RE: Snow Country Landscaping, 35975 US Highway 40

Thank you for the opportunity to comment on the Final PUD, Zone Change, and Lot Line Line Adjustment for Snow Country Landscaping's application (#PL20220029) prepared by Walter Magill of Four Points Surveying and Engineering. This letter serves as a conglomeration of all comments from the City of Steamboat Springs.

Preferred alignment along river near 50 foot setback

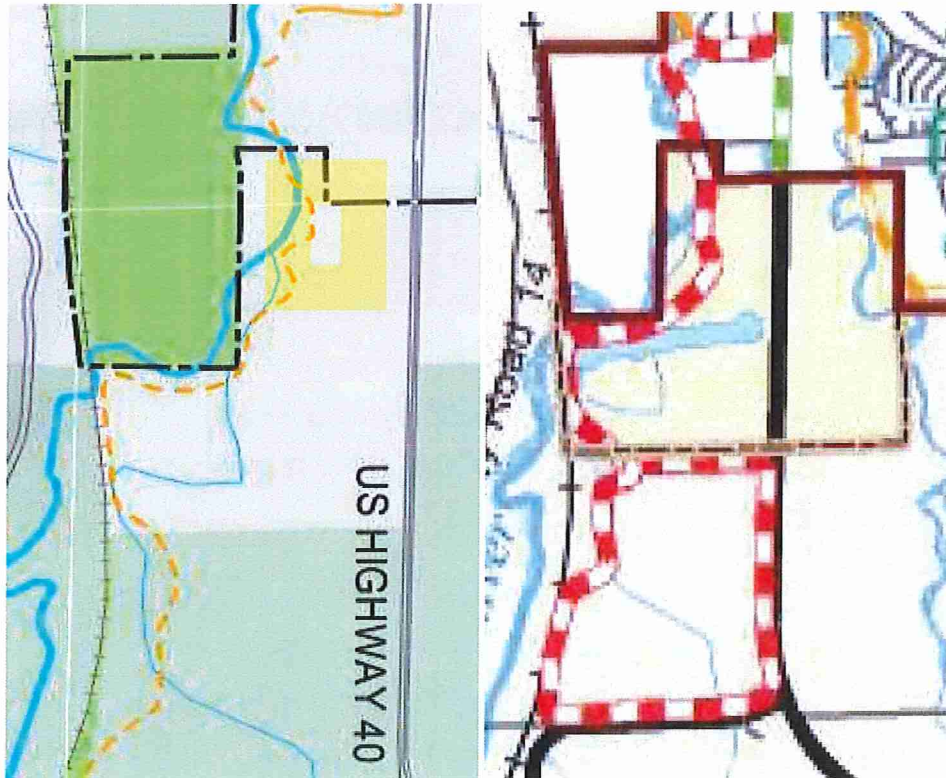
With the proposed replating of the 2 lots, there is an opportunity to locate the trail easement and alignment within the 50-foot building set back of the river corridor or along the subdivision line. While the City appreciates the easements that are proposed, they do not provide the desired connectivity, nor do they meet the vision for the trail corridor that has been identified through decades of community planning.

Below is a property map showing the preferred alignment for the Yampa River Core Trail. The line shown is near the 50' building setback and could be near the lot line amendment. The City is willing to discuss screening opportunities with use of berms (if allowed in floodplain), trees/shrubs, native grass, and 2-rail or chain link fence with signs to allow the trail to pass through the parcel and stay true to the vision for the YRCT. The City may be willing to purchase the easement at the appraised value and would consider development limits such as the trail not being built until easements and construction funding are in place to continue the trail all the way to the Legacy Ranch. The City would typically request a 20-foot easement to allow for construction and maintenance of the trail.

Maps showing YRCT Conceptual Alignment following the Yampa River near the applicant's property

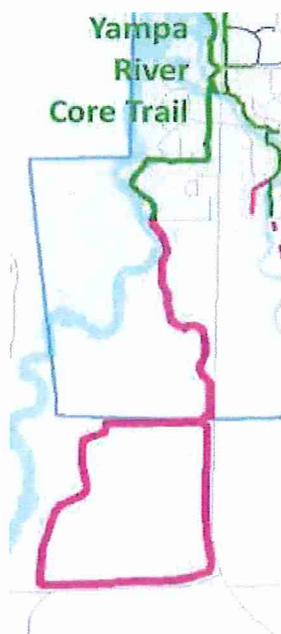
The City of Steamboat Springs began construction of the Yampa River Core Trail (YRCT) in the early 1990's and it is only a small portion of the larger visioned, Yampa River Trail (YRT). The YRT is a recreational trail that has been identified from the headwaters of the Yampa River in the Flattops to the confluence of the Yampa and Green Rivers in Dinosaur National Park. While much of the route is on paved and/or dirt roads, the City of Steamboat Springs chose to provide an off highway recreation trail that followed the meandering path of the Yampa River within its City Limits. The original City trails master plan, the joint 2004 Steamboat Springs Area Community Plan, the joint 2008 Steamboat Springs Area Open Space and Trails Master Plan and the City's 2019 Parks, Recreation, Open Space and Trails Master Plan all show a conceptual route through City Limits following the river corridor. While the route may vary as easements are secured, the intent has always been to follow the river corridor as conditions allowed. Please see the snapshots of maps from City and City/County adopted plans below and the alignment at the City's

southern limits. While easements have not been secured from the existing terminus of the trail at City Limits to Legacy Ranch, the City has requested the preferred easement from the applicant along the river through these 2 parcels.
